CLEAR CREEK SUBDIVISION

Engineering Comments: FINAL PLAT COMMENTS (should be addressed prior to submitting the FINAL PLAT for review and/or signature by the City Engineer):

APPLICATION NUMBER 3 DATE March 21, 2019

DETAIL SITE PLAN

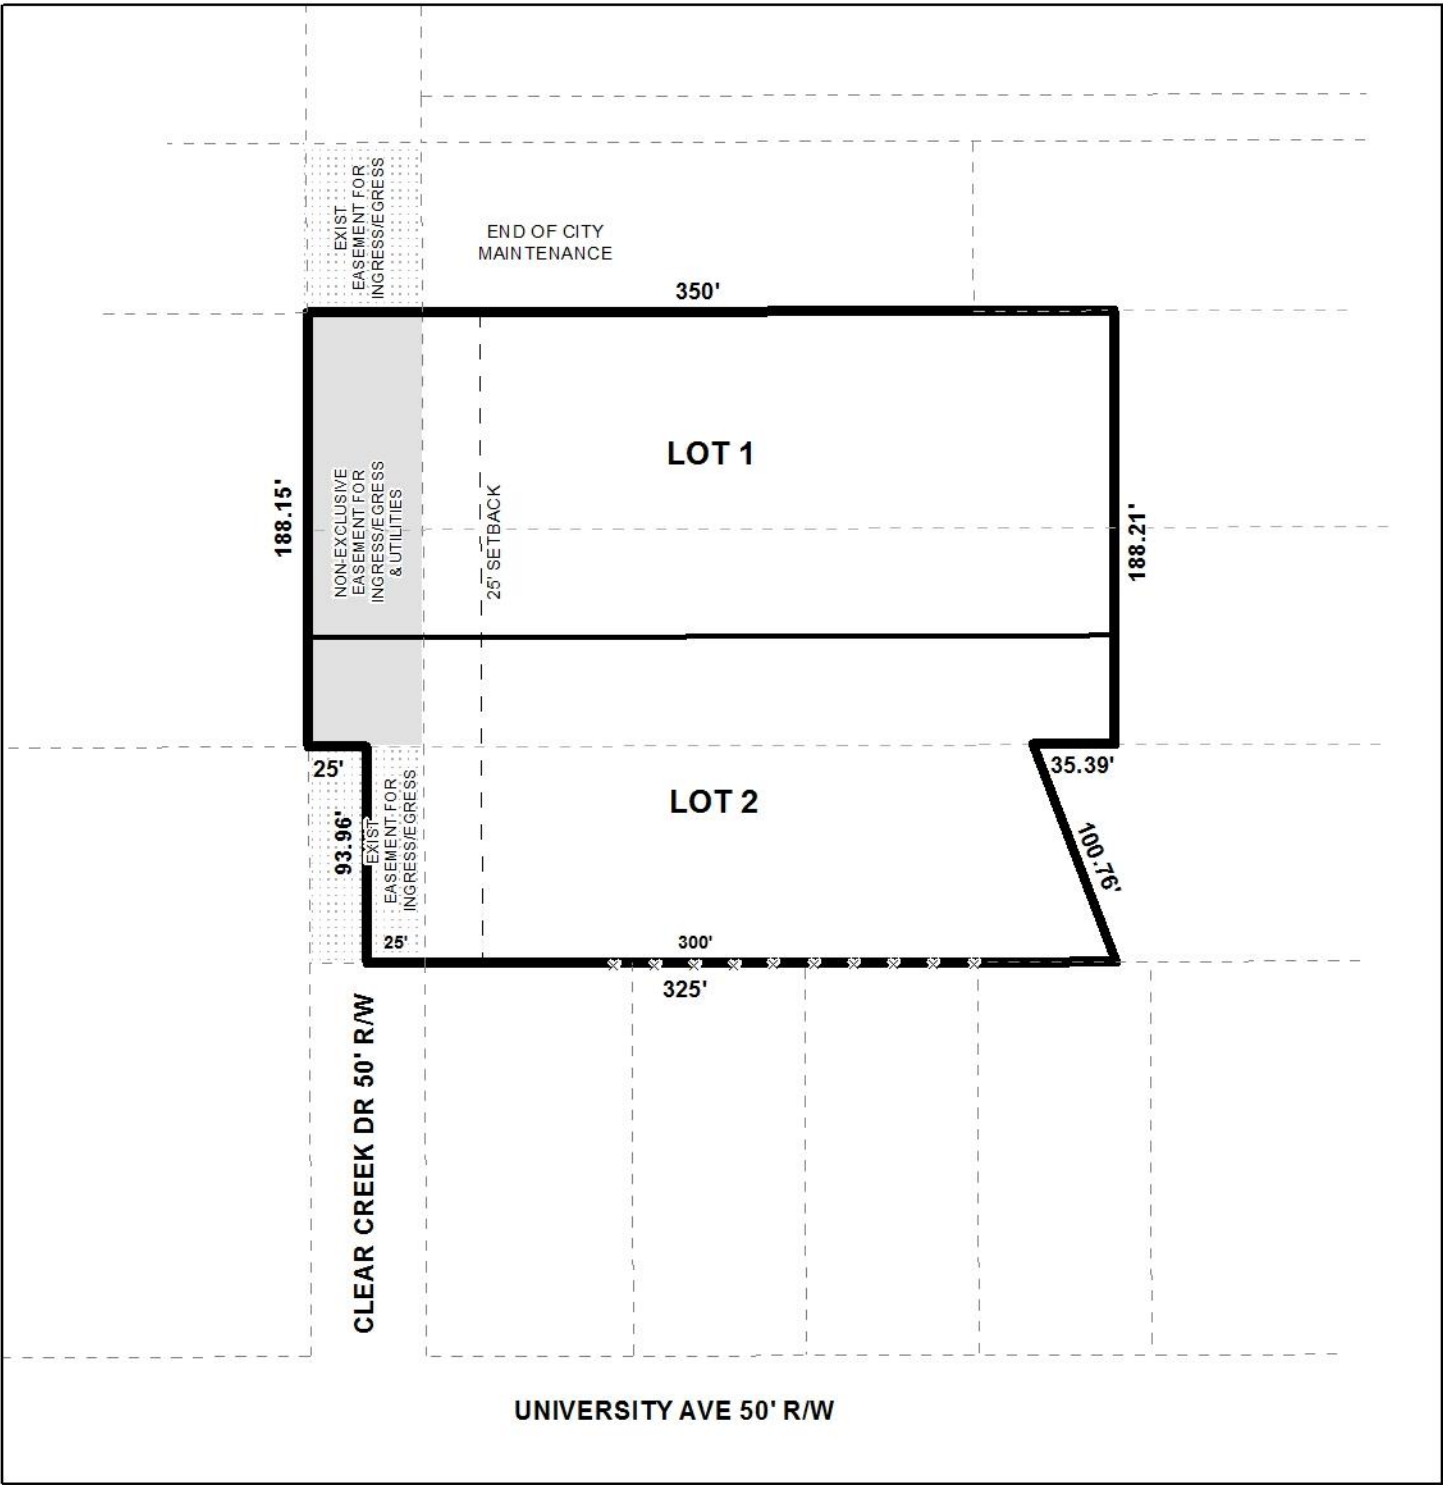
The applicant's narrative, as well as the proposed site plan, indicate existing easements for ingress/ egress to the North of the subject site, as well as in front of a portion of the proposed Lot 2. However, there was no documentation provided with the application supporting this information. Copies of both existing easements should be submitted to the Planning and Zoning Department for staff's review. The applicant also proposes to dedicate 50' from Lot 1 and a portion of 50' and 25' from Lot 2 to create a continuous non-exclusive easement.

It should also be pointed out; the newly proposed plat appears to exclude a portion of the proposed Lot 2 located in the southeast corner of the lot. The plat that was submitted with the 2018 application depicted the rear portion of all the lots as straight lines as opposed to the indentation proposed on Lot 2. The inclusion of all of the property identified within the parcels must be depicted on the plat, and be included in the subdivision process.

- 1) submission of documentation of both the existing easements for ingress and egress; and
- 2) inclusion of all of the property identified within the parcel to be a part of Lot 2 and additional postage if required.
